RECONSTRUCTION OF SR 3 / US 19/41
Project No. NH-001-4 (47)
Spalding County, Georgia

Value Engineering Study Report
Preliminary Design Submittal

November 2008

ALTERNATIVE NO.: B-6

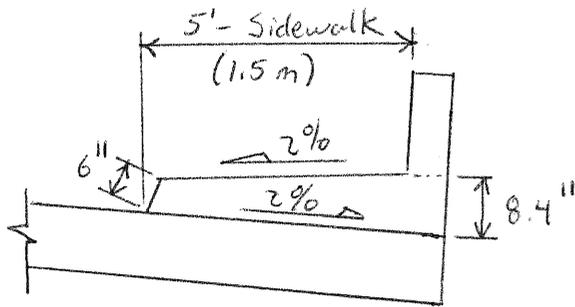
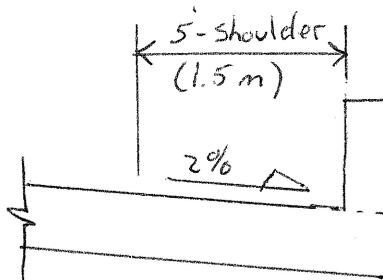
DESCRIPTION: **REMOVE BRIDGE SIDEWALK AND REDUCE SHOULDER WIDTH**

The original design uses a 5-ft.-wide raised sidewalk on the bridge.

Use a 5-ft. shoulder with no raised sidewalk.

To remove the sidewalk and add a shoulder, the shoulder would typically be 10- ft.-wide. Reduce the shoulder to a 5-ft.-wide rural shoulder. Most businesses are north of the bridge. Therefore, sidewalk could be stopped before the bridge.

Alt. D-2 Sheet 2 of 9

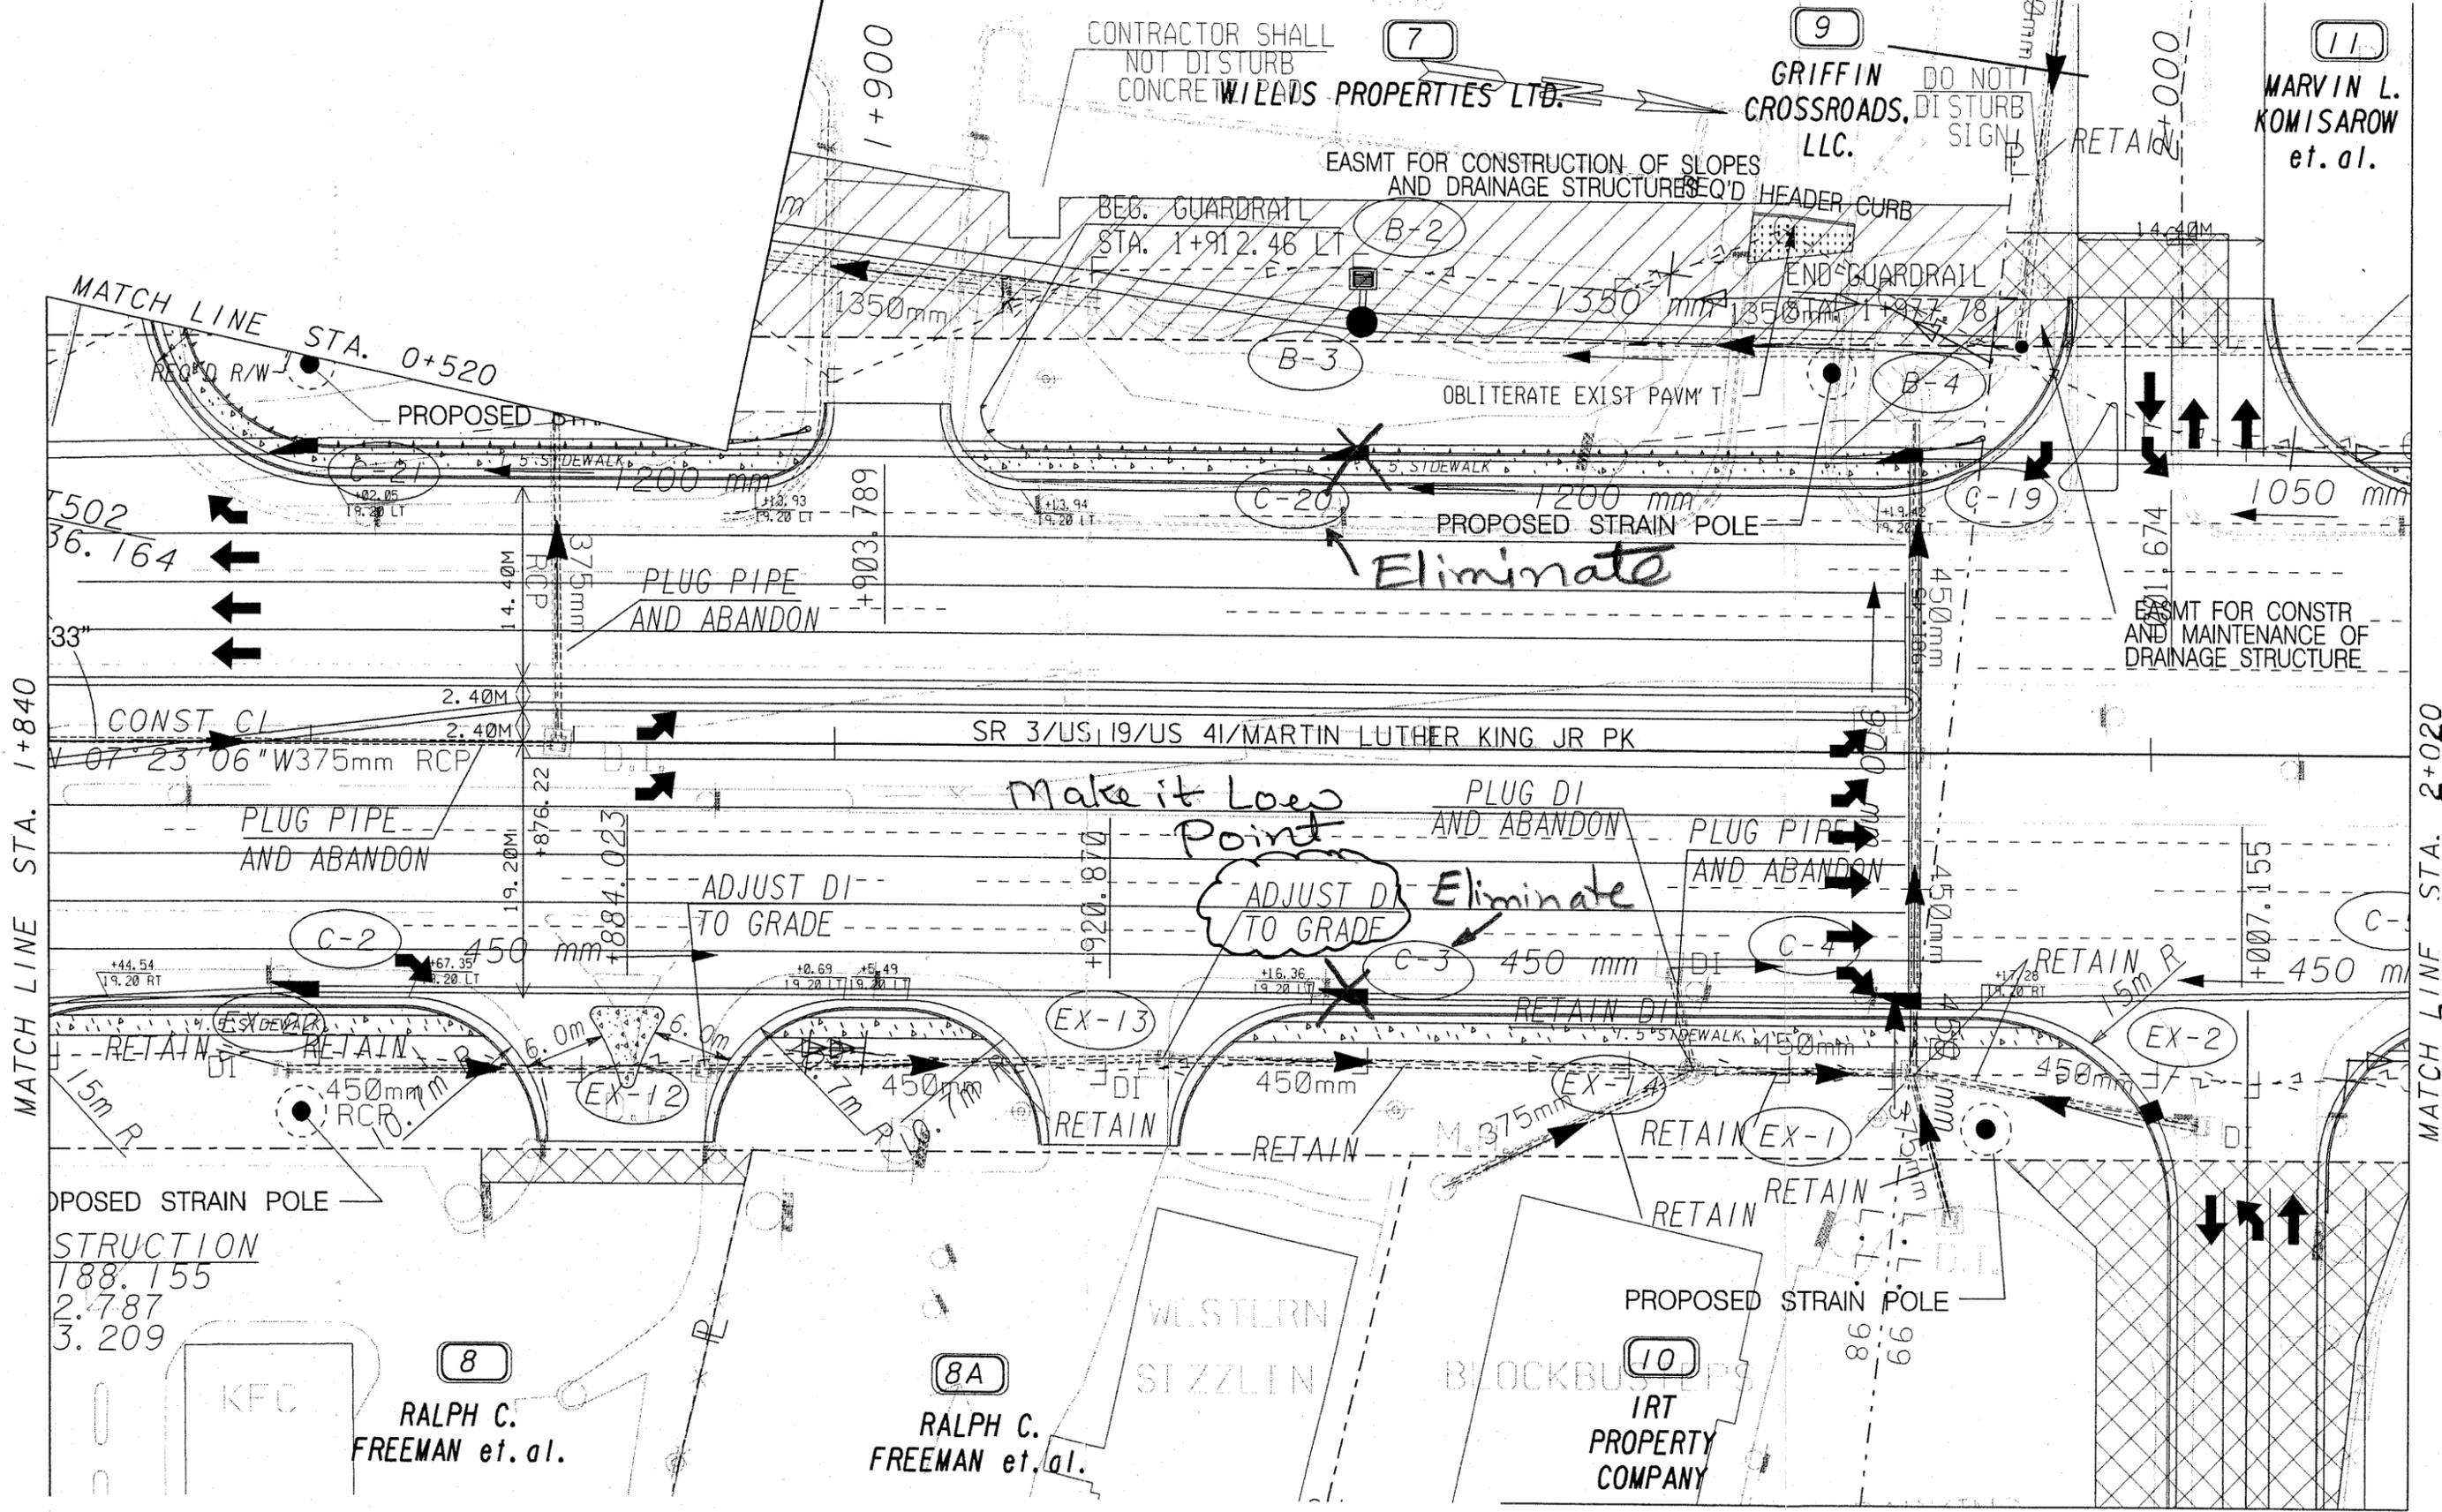
Due to the lack of necessary data, the team did not perform hydraulic calculations. The suggestions outlined in the following pages are based on the experience of the VE team and the assumptions that the gutter spread (typically 8 ft.) limit is not violated.

Alt. D-3 Sheet 5 of 13

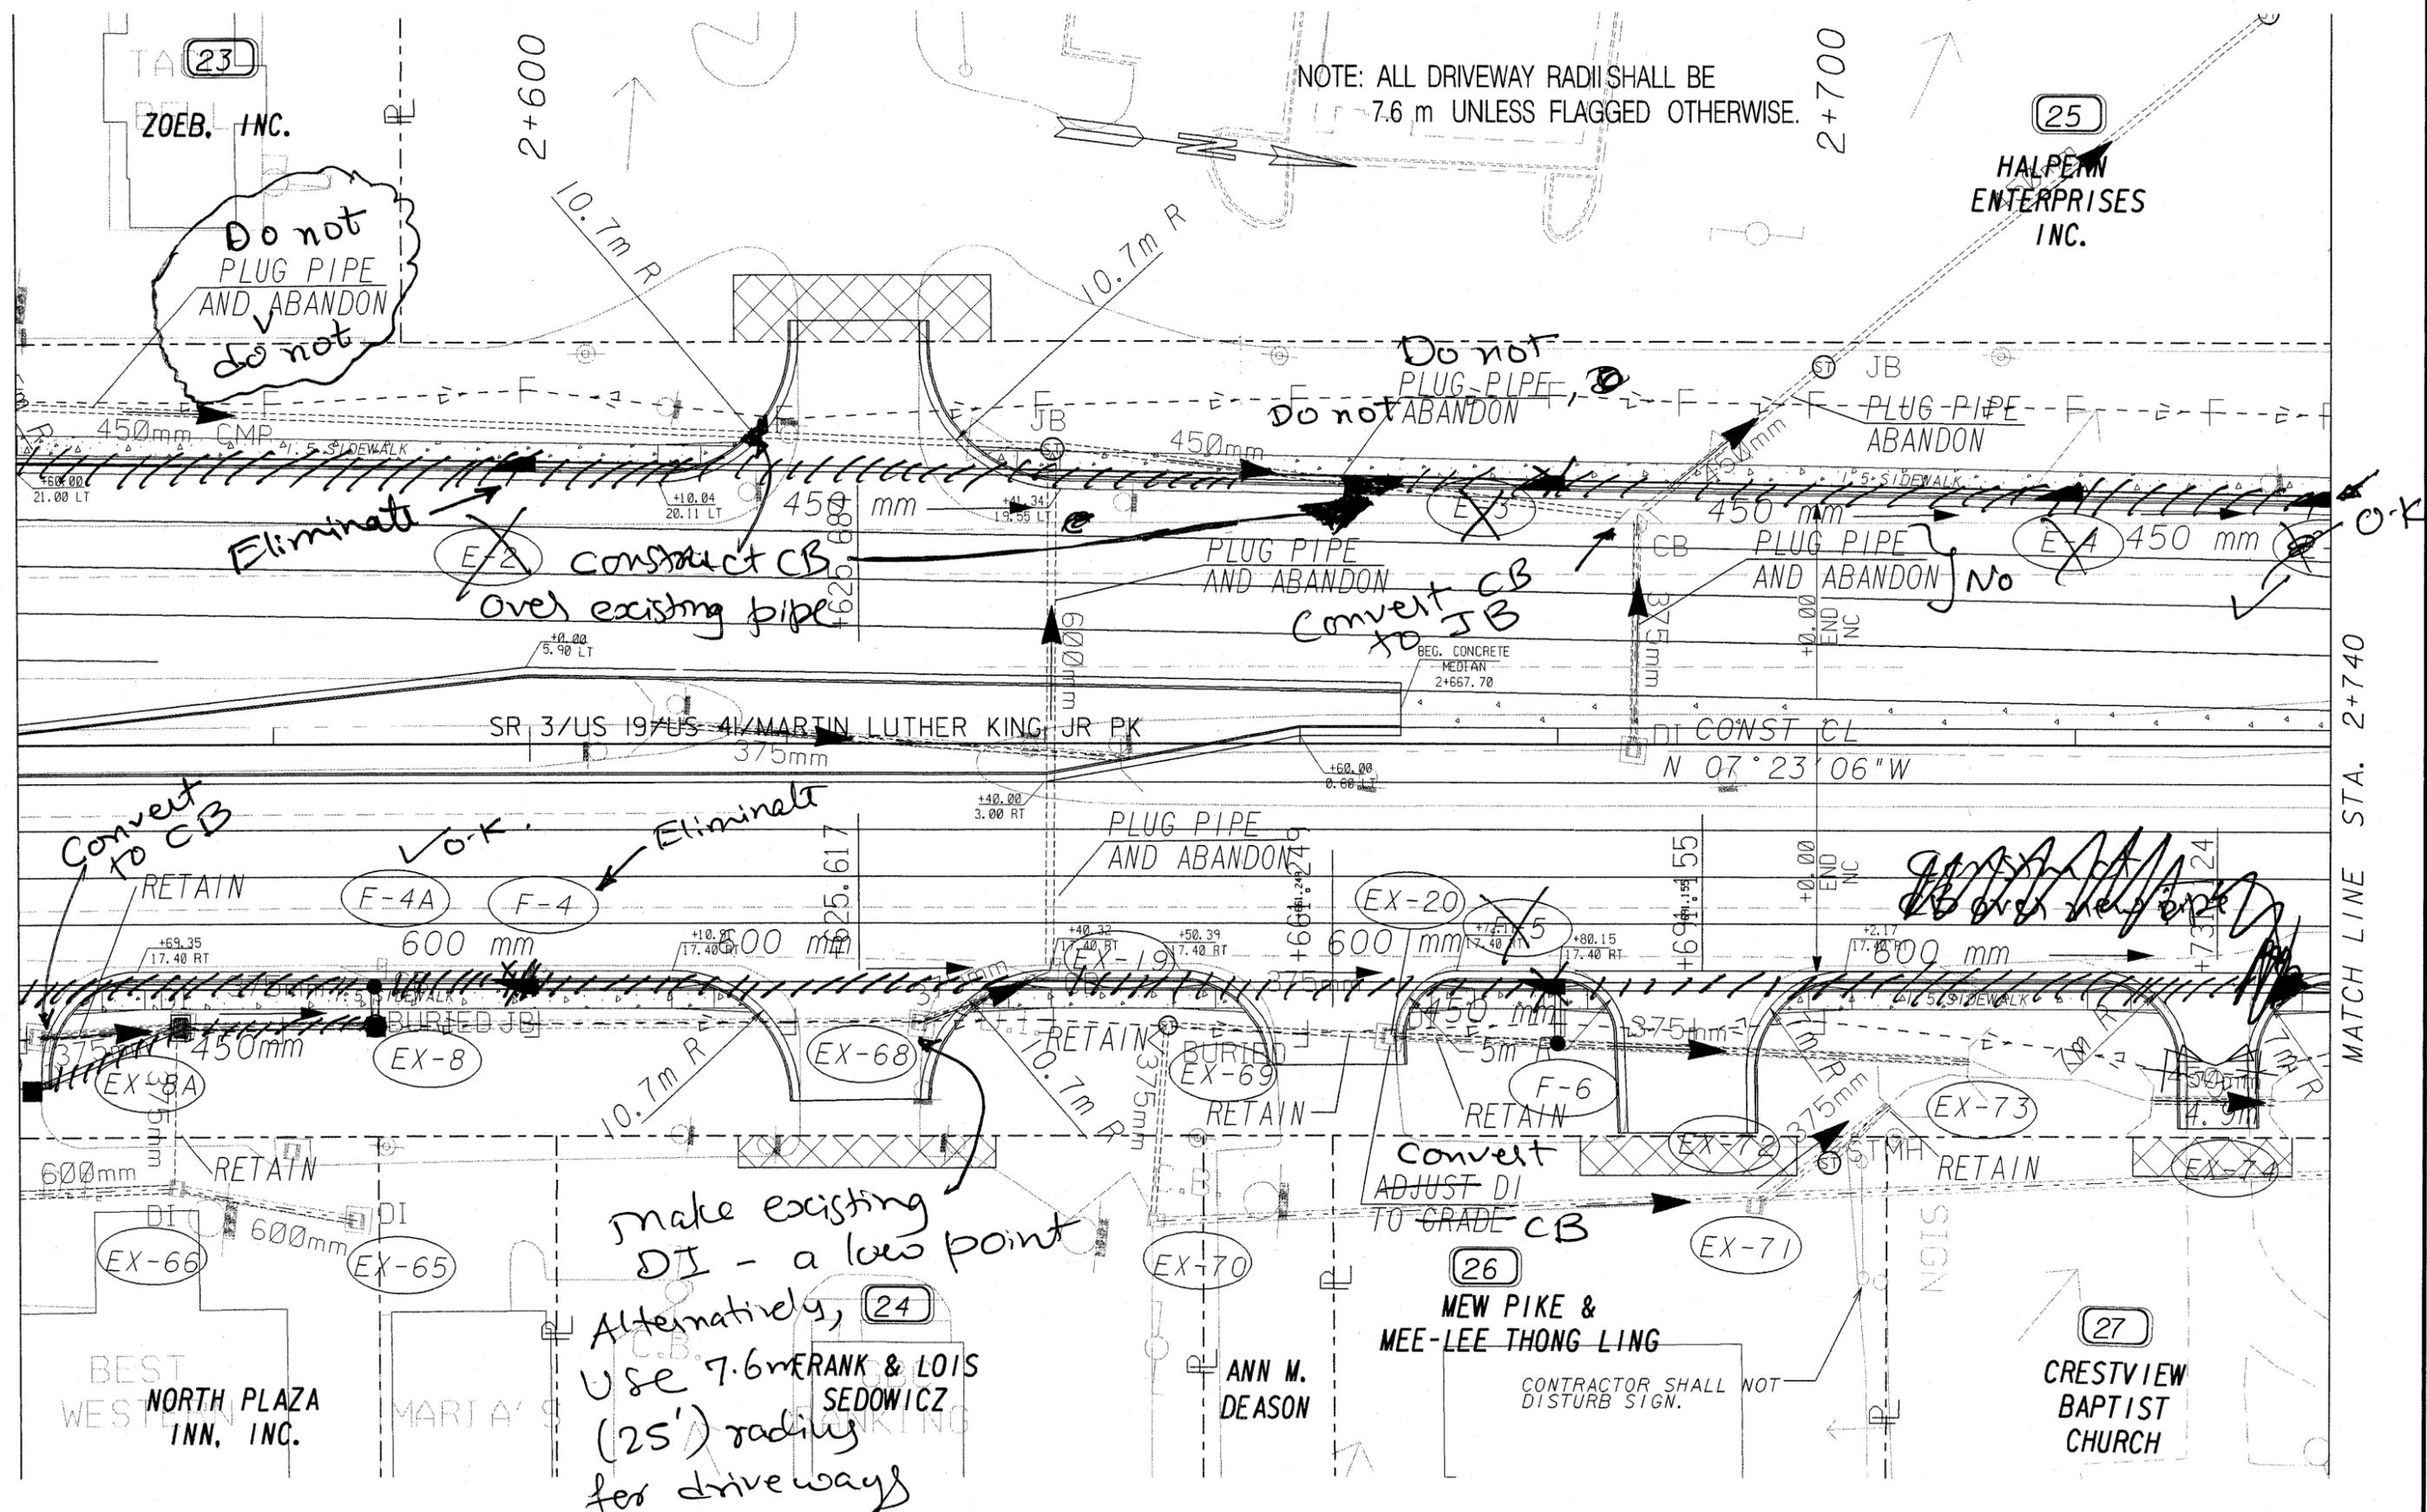
Do not PLUG PIPE AND ABANDON Do not

Original Design

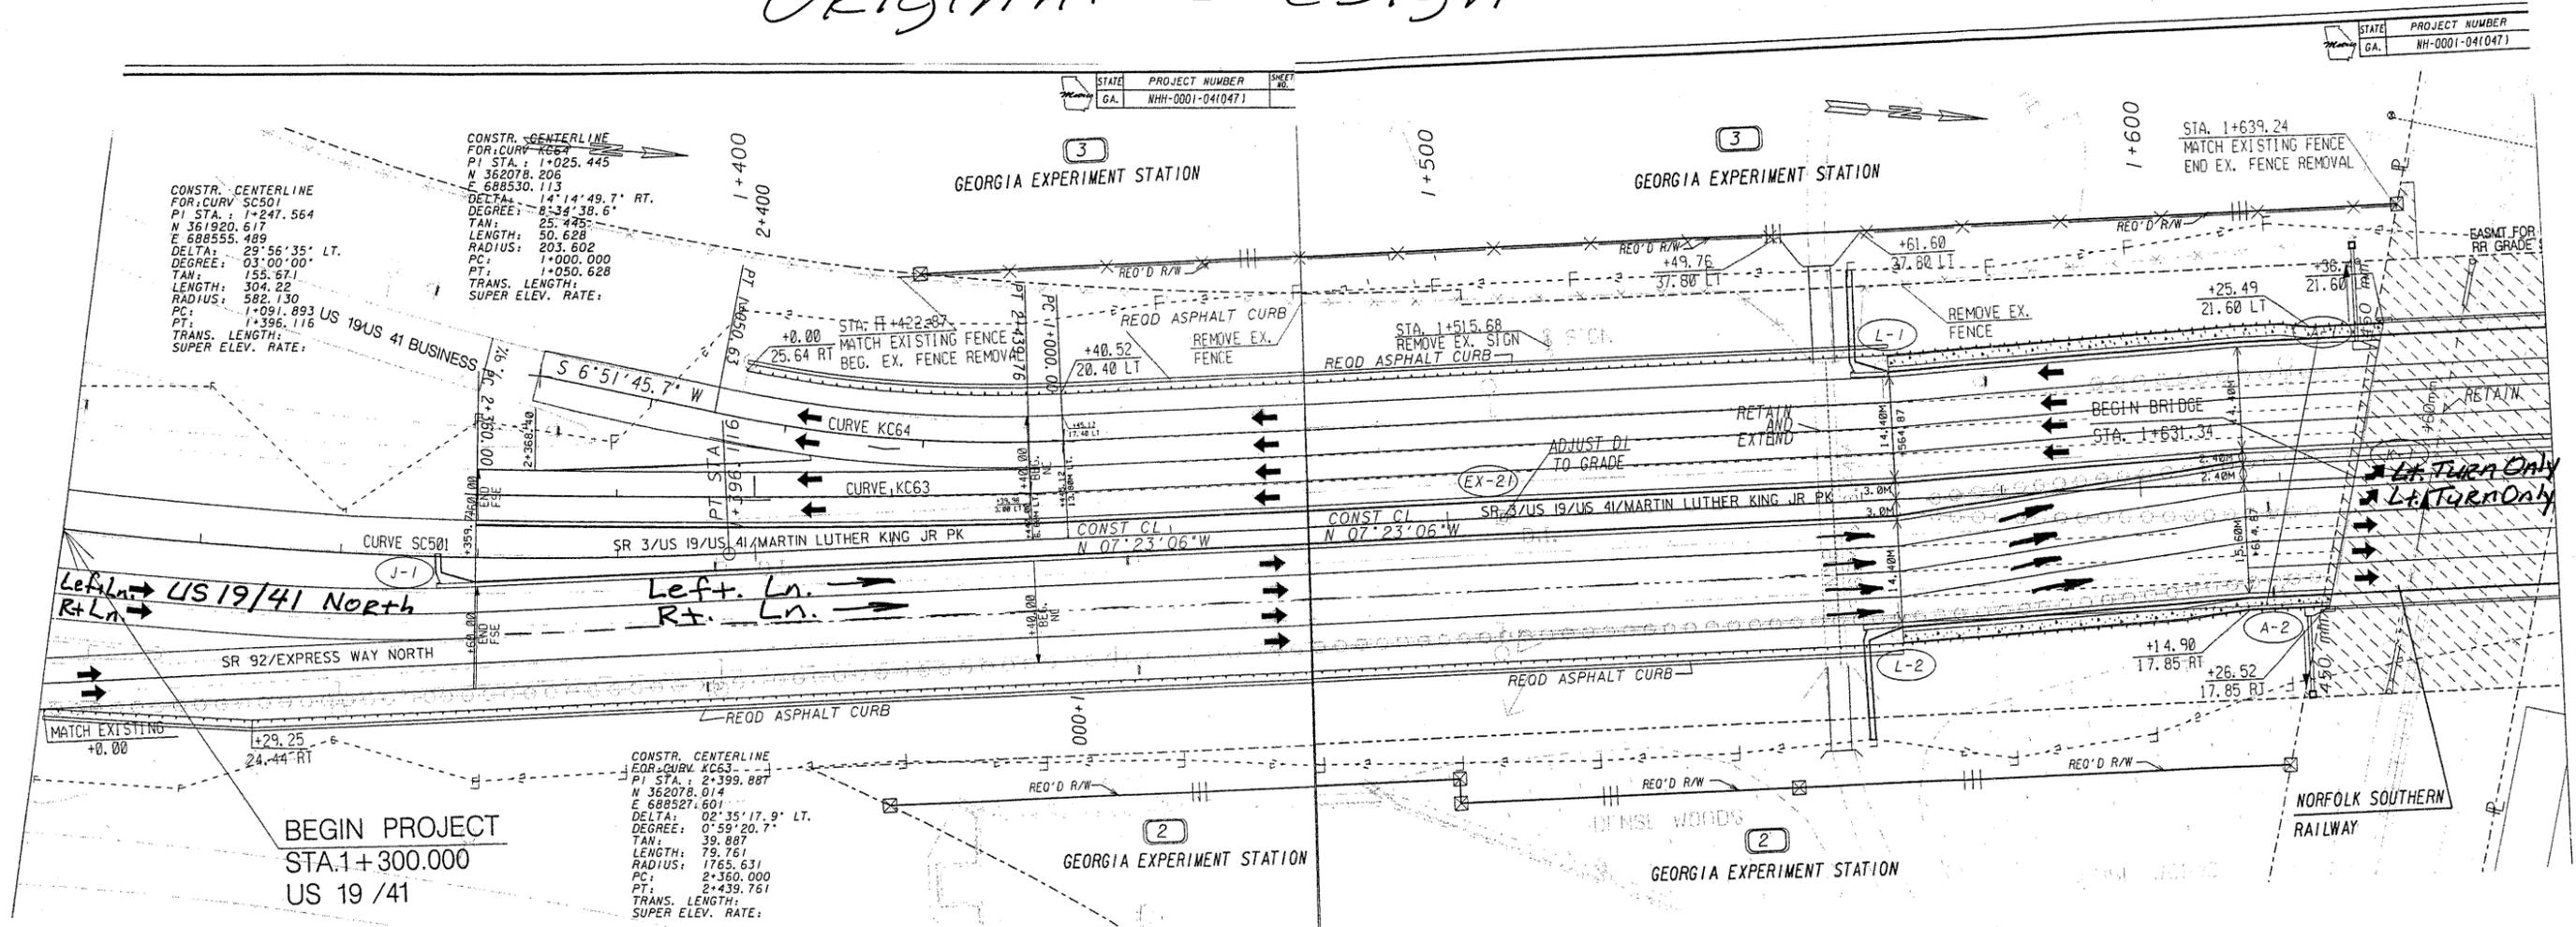
The present lane layout for US 19/41 has the two northbound lanes shifting towards the median, then these lanes become left-turn only lanes. This would require a vehicle in the left northbound US 19/41 lane to weave two lanes to get to the closest through lane for this section of US 19/41. The alternative design requires a weave of only one lane.
